Øǻ æ Precursor Analysis

Accident Sequence Precursor Program --- Office of Nuclear Regulatory Research

Quad Cities 2	Loss of offsite power to Unit 2 but not Unit 1 due to failure of Unit 2 main power transformer with the subsequent failure of a switchyard breaker relay	
Event Date: 08/02/2001	LER: 265/01-001	CCDP = 5×10^{-6}

Attachment B - Resolution of Comments

Figure 1. Quad Cities Units 1 and 2 loss of offsite power event tree.

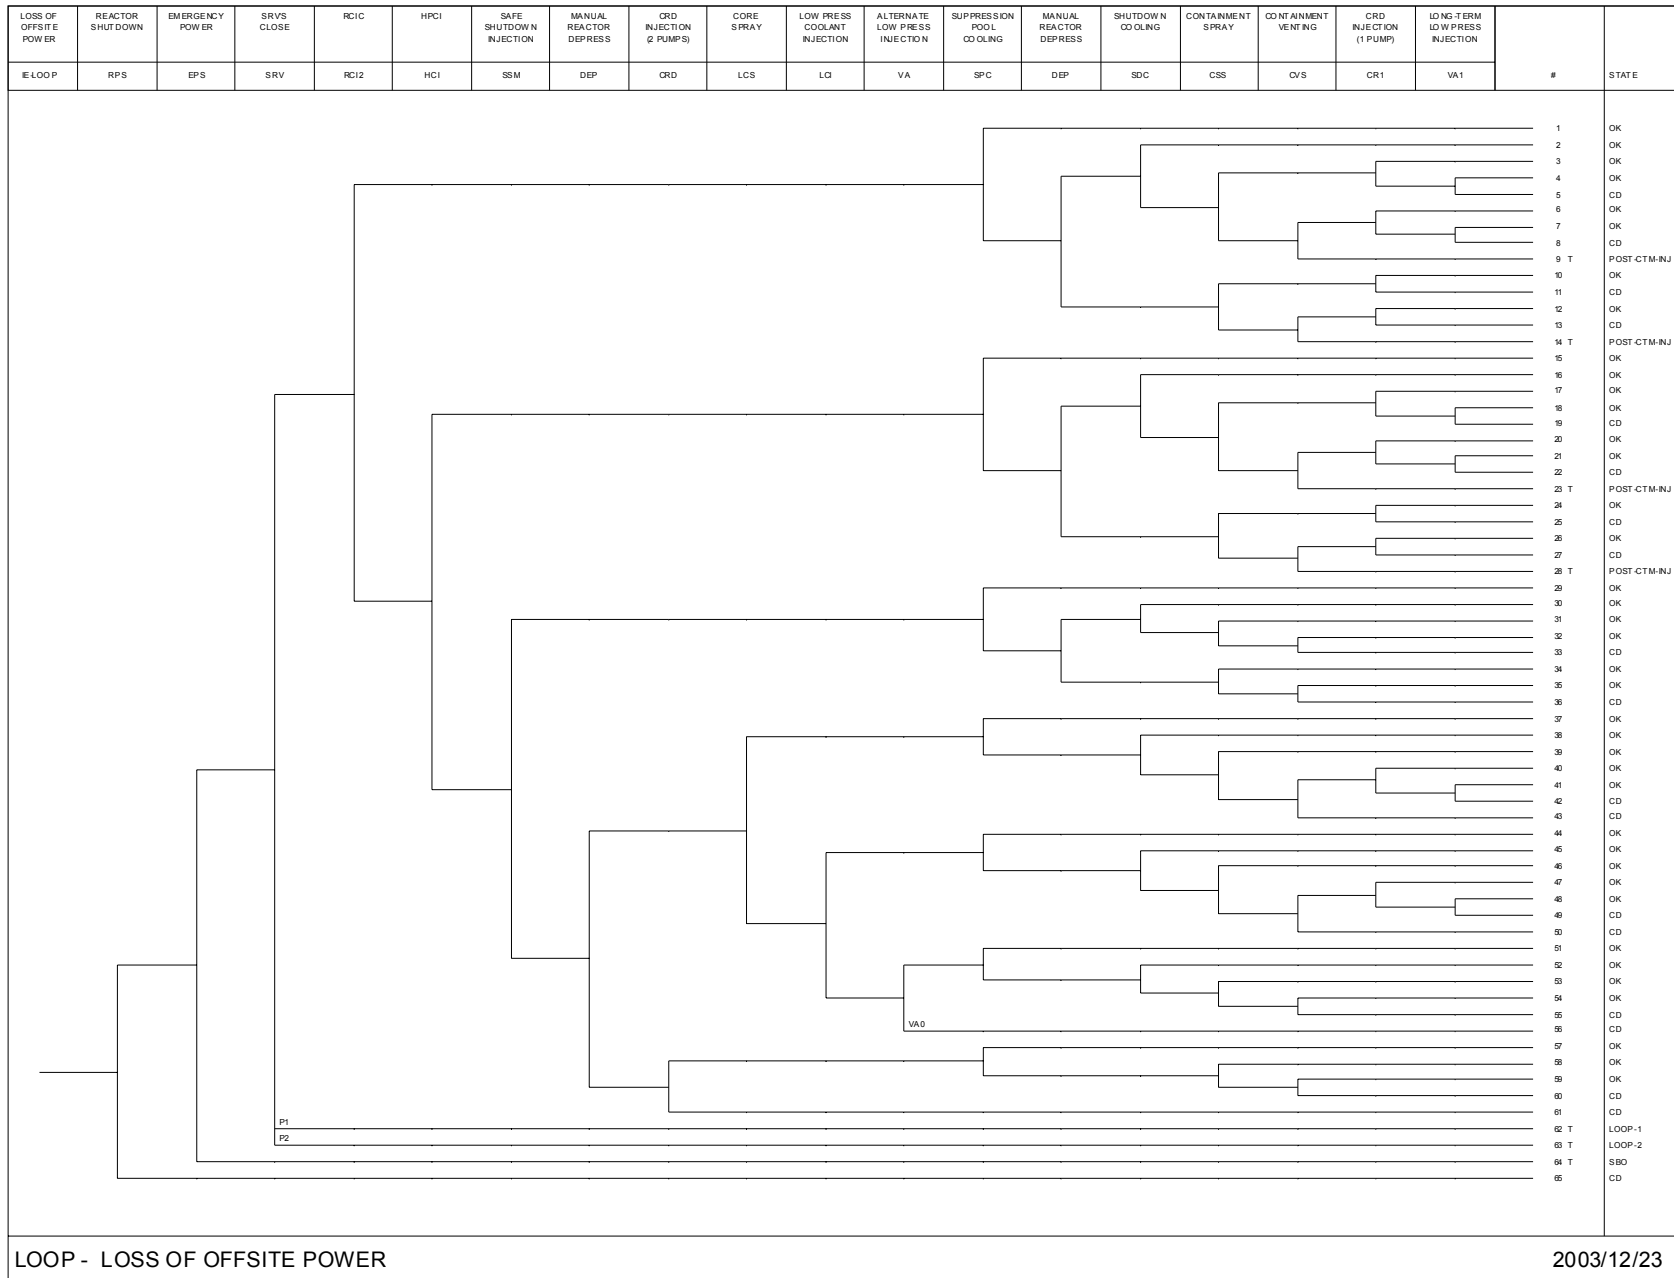
Licensee's Comment 4.6: 44% of the SPAR model risk comes from Anticipated Transient Without Scram (ATWS). It is surprising that ATWS would be such a large fraction of LOOP risk, and more surprising that it would be the dominant source. It appears that the size of this contribution is not realistic, and it appears that the reason is a modeling decision to take no credit, for the LOOP initiator, for the ordinary Emergency Operating Procedure actions to respond to an ATWS. To accurately represent risk, the SPAR model should be improved to give that credit. Doing so would reduce the ATWS contribution to LOOP by between one and two orders of magnitude. The Exelon PRA does give that credit, and the top corresponding LOOP/ATWS cutset (LOOP frequency set to 1.0) has a probability of 3.8×10^{-8} .

Licensee's Comment 4.7: ATWS probabilities for QCNPS are based on NUREG/CR-5500, volume III. The mechanical ATWS probability is 2.1×10^{-6} and the electrical is 3.7×10^{-6} . It is interesting to observe that the SPAR probabilities appear to be significantly smaller. The SPAR event RPS-SYS-FC-CRD, "Control rod drive mechanical failure," has a probability of 2.5×10^{-7} . The sum of two electrical SPAR events, RPS-SYS-FC-PSOVS, "HCU scram pilot SOVs fail," and RPS-SYS-FC-RELAY, "Trip system relays fail," is $(1.7 \times 10^{-6} + 3.8 \times 10^{-7}) = 2.1 \times 10^{-6}$. EGC requests that the NRC Staff please provide the bases for the SPAR ATWS probabilities.

Response: Exelon is correct in noting that the reason why failure of the reactor protection system (RPS) is such a large fraction of the SPAR model CCDP comes from the modeling assumption to take no credit for the transfer to ATWS event tree following a LOOP with subsequent failure of RPS.

The NRC is considering adding logic to the SPAR models to credit the transfer to the ATWS event tree at Quad Cities following a LOOP and failure of RPS. The NRC would like to make the SPAR models for Quad Cities more realistic with respect to this assumption. However, the SPAR model cannot be changed without documentation verifying the change is appropriate and technically correct. The NRC presently does not have such documentation.

The NRC appreciates your effort to improve the SPAR model for Quad Cities, but the model will remain as stated in the precursor report unless Quad Cities can provide the NRC with the appropriate documentation for changing the model. We would appreciate Quad Cities forwarding to the NRC documentation of the analysis (neutronic and thermal hydraulic) that permits Quad Cities to take credit for the transfer to ATWS event tree following a LOOP and failure of RPS. The NRC would also appreciate copies of the plant-specific emergency operating procedures that guide the Quad Cities operators through the event - LOOP followed by failure of RPS.

Response: The basis for the SPAR ATWS probabilities is NUREG/CR-5500, Volume 3. This can be seen in a comparison of LOOP Sequence 65 in Table 3 of the SPAR analysis to Tables 5 and 6 on pages 23 and 24, respectively, of NUREG/CR-5500, Volume 3.
